Planning Sub-Committee B

Monday 7 September 2015

Supplemental Agenda No.1

Item No: 7.	Classification: Open	Date: 7 September 2015	Meeting Name: Planning Sub-Committee B
Report title:		Addendum Late observations, consultation responses, and further information.	
Ward(s) or groups affected:			
From:		Head of Development Management

Appendix 1

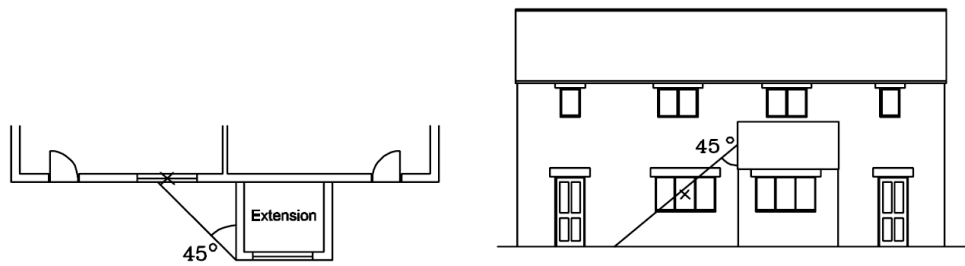
- 3.1. Paragraph 20 should refer to the occupiers of 195 Merrow Street.
- 3.2. Paragraph 24, for clarity, officers have independently undertaken a 45 degree test on this application, please refer to the appendix 1 in relation to further guidance on the 45 degree rule.
- 3.3. Paragraph 27 should refer to the impacts at 199 Merrow Street.
